From: Elton, Loree [leelton@STPEGS.COM]
Sent: Tuesday, December 21, 2010 8:25 AM
To: Muniz, Adrian
Subject: RE: Letter 268
Attachments: U7-C-STP-NRC-100268 P2.pdf

From: Elton, Loree
Sent: Monday, December 20, 2010 4:16 PM
To: 'Adrian Muniz'
Subject: Letter 268

RAI 03.07.02-25**QUESTION:****Follow-up Question to RAI 03.07.02-16 (STP-NRC-100036)**

Figure 03.07.02-25.1: Node locations for spectra comparison on Original SSI Model (North is along Y-Axis)

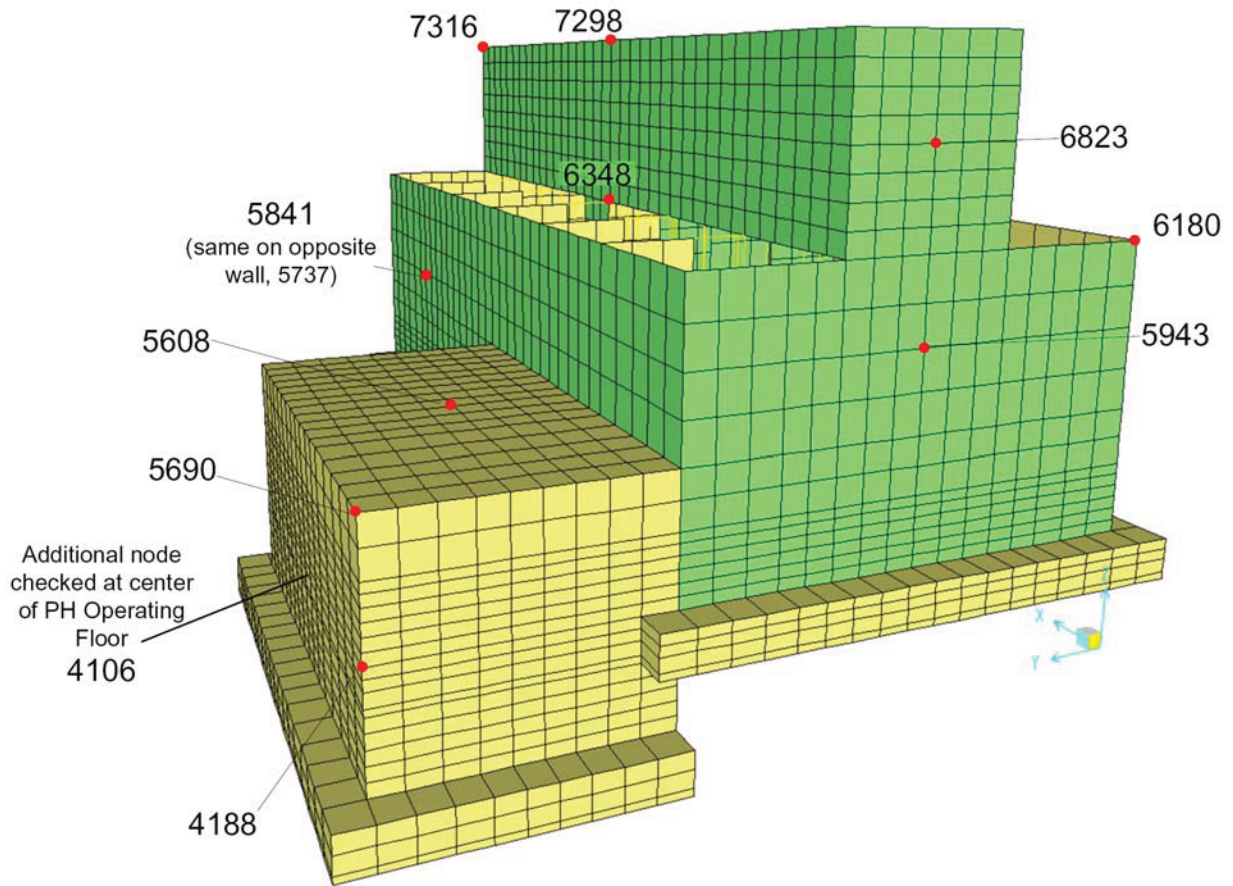
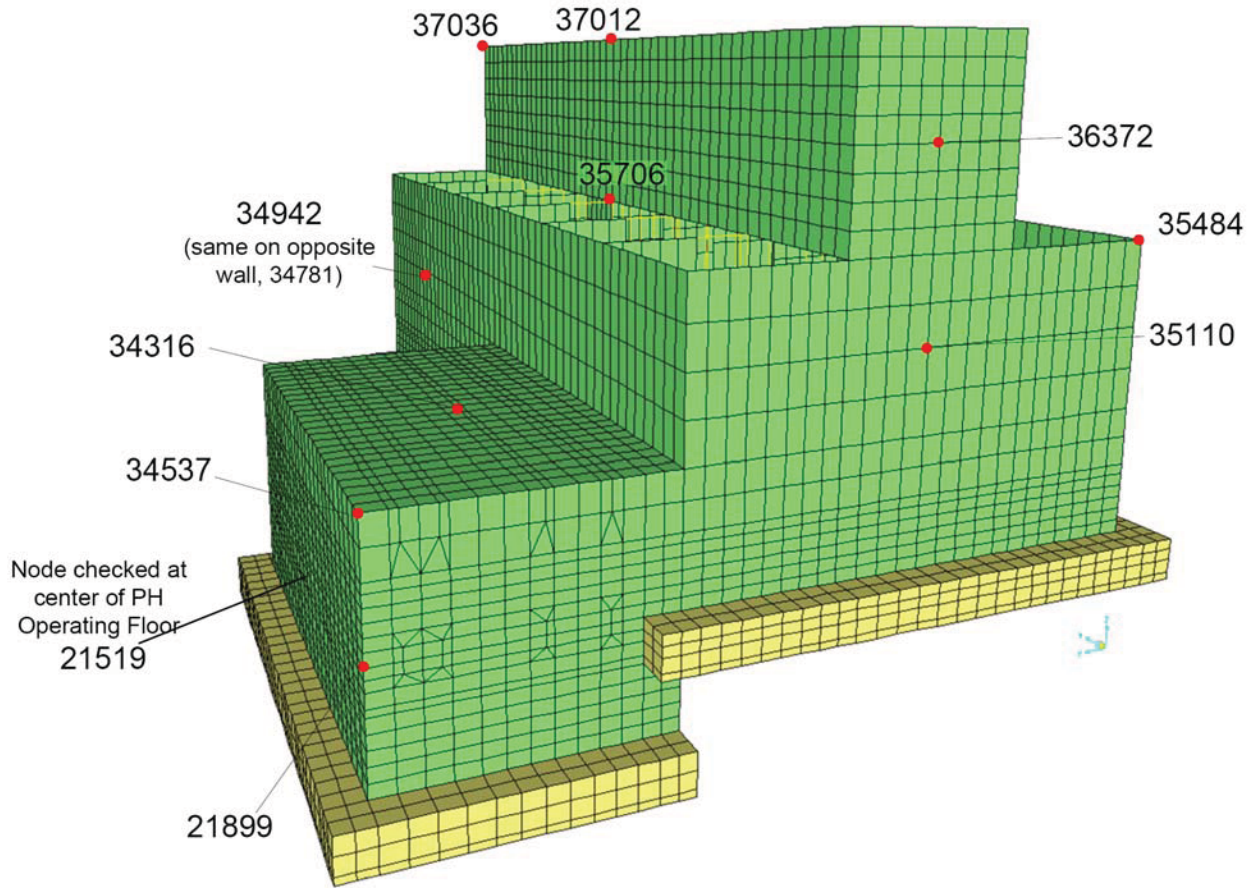
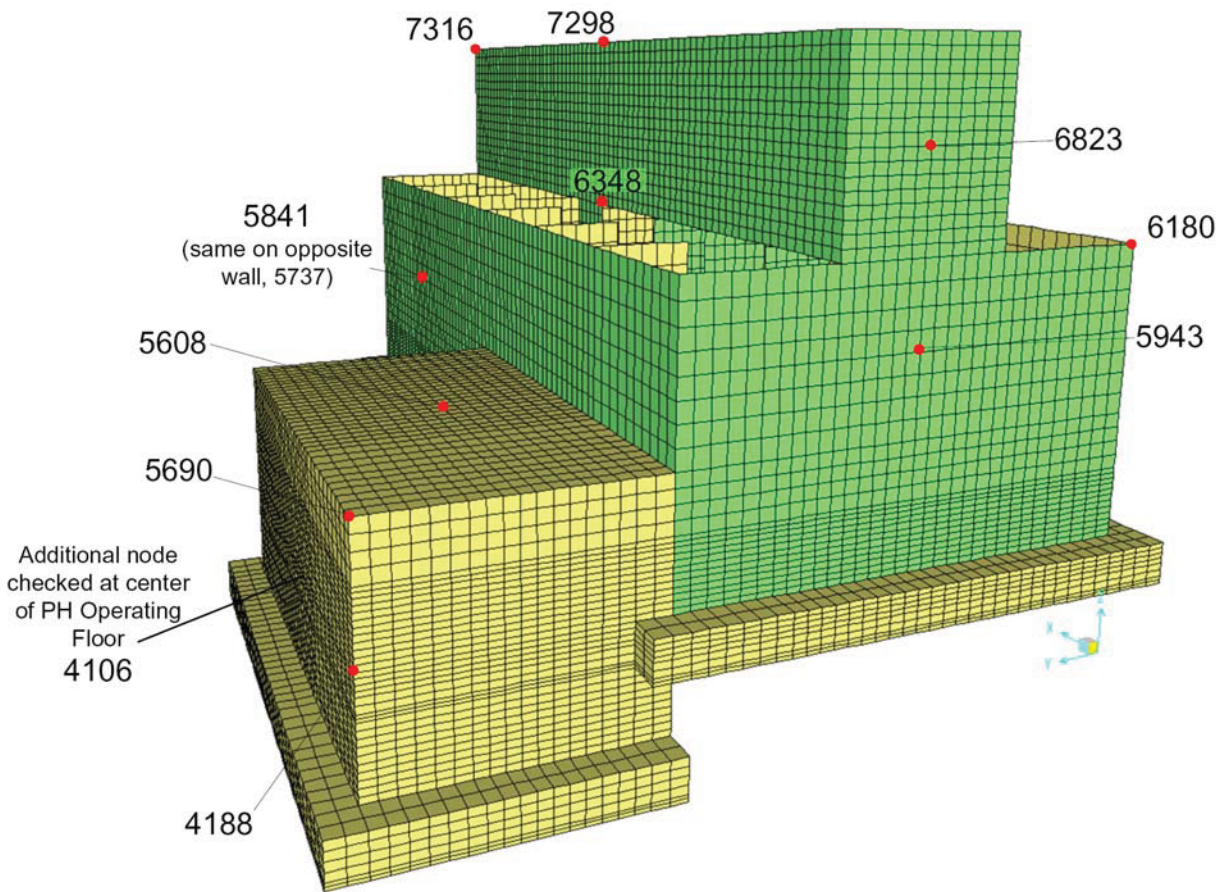
10CFR50, Appendix S requires that evaluation for SSE must take into account soil-structure interaction (SSI) effects. In the response to Item 1 of RAI 03.07.02-16 with regard to the adequacy of the structural mesh size used in the SSI analysis, the applicant has presented comparisons of the first two modes of the fixed-base structure in the E-W direction ($f_1 = 2.133$ and $f_2 = 2.056$ Hz) and N-S direction ($f_1 = 3.187$ and $f_2 = 3.028$ Hz) calculated using the SSI and design meshes. Although the comparisons of the two modes are good, they only represent a mass participation of about 17.1% and 15.4% for the E-W and N-S directions, respectively. In addition, the local modes are not reflected in these comparisons. As such, the applicant is requested to provide comparisons of the higher modes that include the out-of-plane modes of the slabs and walls to ensure the adequacy of the SSI mesh for transmitting frequencies of at least 33 Hz. This should include comparisons of in-structure response spectra of slabs, roofs and wall panels for the fixed-base structure calculated using the coarse SSI and fine design meshes subject to representative horizontal and vertical foundation motions. The staff needs this information to determine that the coarse mesh size (for modeling the structure) used in the SSI analysis is adequate for evaluation of SSI effect.

- Figures 03.07.02-25.1 thru 03.07.02-25.3 show original SSI model, refined SSI model, and refined structural model, respectively. Figures 03.07.02-25.6 thru 03.07.02-25.8 show Pump House roof to the same scale from the original SSI model, refined SSI model, and refined structural model, respectively.

- The node locations for comparison of in-structure response spectra are shown in Figures 03.07.02-25.1 thru 03.07.02-25.3 for the original SSI model, refined SSI model, and refined structural model, respectively. These locations include the Pump House Operating Floor, Pump House Roof, UHS Basin Walls, and UHS Cooling Tower Walls. The node locations for comparison of maximum accelerations, in addition to those locations for comparison of in-structure response spectra, include those shown in Figures 03.07.02-25.4 and 03.07.02-25.5.

Figure 3H.3-50: SSI and SSSI Lateral Seismic Soil Pressures (psf) on Radwaste Building East Wall

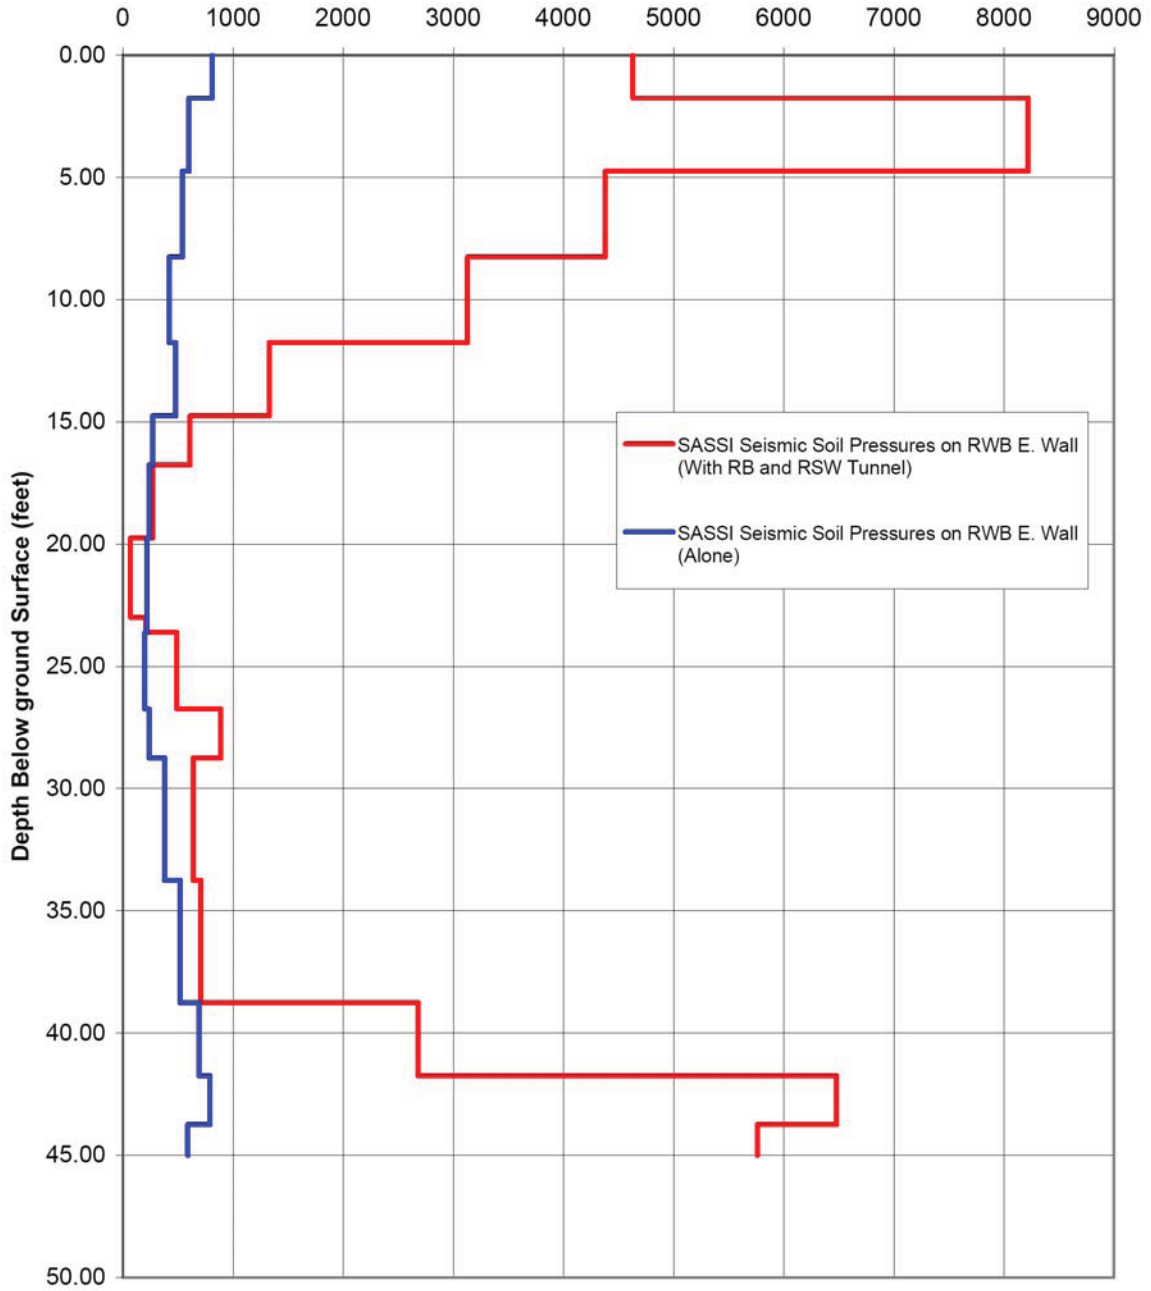
The COLA markup provided in the response to RAI 03.07.02-19, Revision 1 describes the procedure for establishing the SSE input at the foundation level of the RWB. According to this procedure, five interaction nodes at the depth corresponding to the bottom elevation of the RWB foundation will be added to the 3-D SSI model of the Reactor Building (RB). These five nodes correspond to the four corners and the center of the RWB foundation. The RB SSI model is analyzed for the STP site-specific SSE. The envelop of the resulting response spectra at the foundation level of the RWB (based on the average of responses at the 5 nodes) and 0.3g Regulatory Guide 1.60 response spectra will be used as the design response spectra for II/I evaluation of the RWB. This procedure for estimating the foundation input motion for the seismic SSI response analysis of non-Category I structures is acceptable. However, the procedure does not address the potential increase in dynamic soil pressures on the exterior walls of RWB due to the SSSI effects. The applicant is requested to describe how the increase in dynamic soil pressures on the RWB walls due to the SSSI effects will be accounted for in the design of the RWB exterior walls. The staff needs this information to ensure that the RWB exterior walls are adequately designed to maintain its structural integrity during a SSE in controlling any potential release of radioactive materials to the environment.

The resulting seismic soil pressures on the east and west walls of the RWB from the SSSI analysis are shown in Figures 3H.3-50 and 3H.3-51 in Enclosure 1, respectively.

The RWB east and west walls have been evaluated considering the SSSI seismic soil pressures in Figures 3H.3-50 and 3H.3-51. The evaluation confirmed that the existing design as reported in response to RAI 03.08.04-18, Revision 1, (submitted with letter U7-C-STP-NRC-100124 dated June 2, 2010) is adequate.

The RWB east and west walls are also designed for lateral seismic soil pressures shown in Figures 3H.3-50 and 3H.3-51, respectively. These soil pressures consider the structure-soil-structure interaction (SSSI) between the RWB, RSW piping Tunnel, and RB. For details of this SSSI analysis, see Section 3H.6.5.3.
